Date: October 30, 2012  
File #: 09 - 312701  
Folder Name: 606 MARYLAND AVE E  
PIN: 292922120095

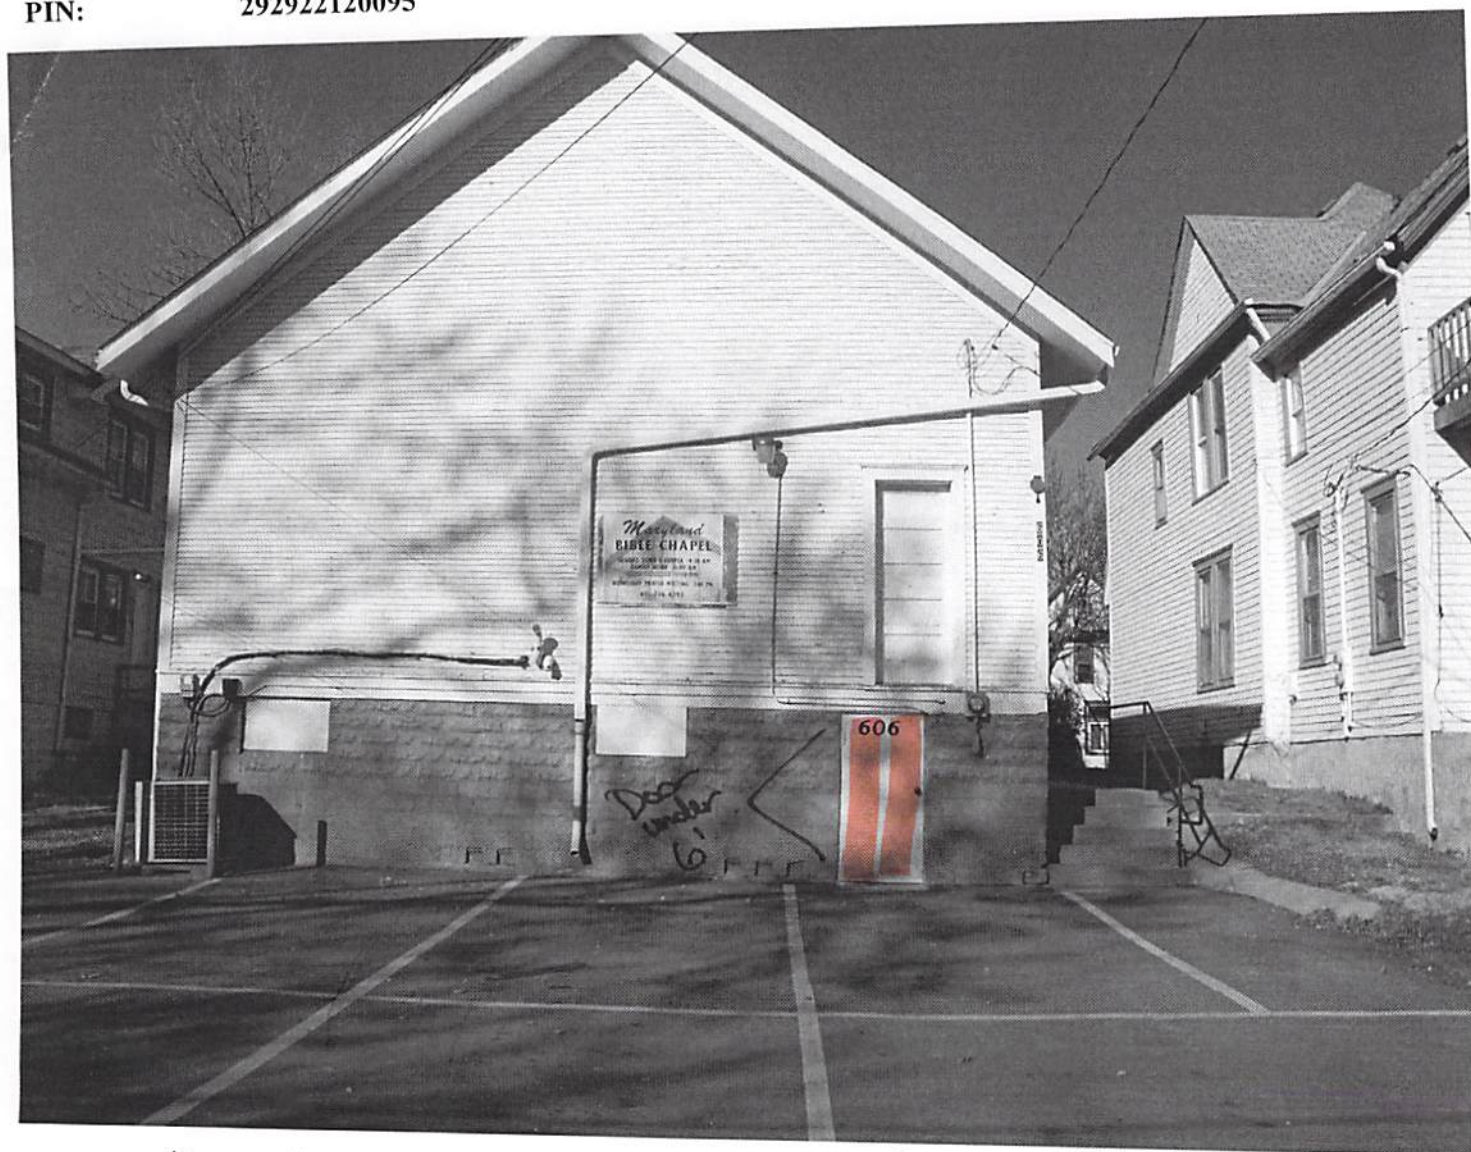
goes through intervening space, (kitchen)  
door under 6' - therefore, can't be  
counted as a 2nd exit

door under to  
open through interior space (interior)
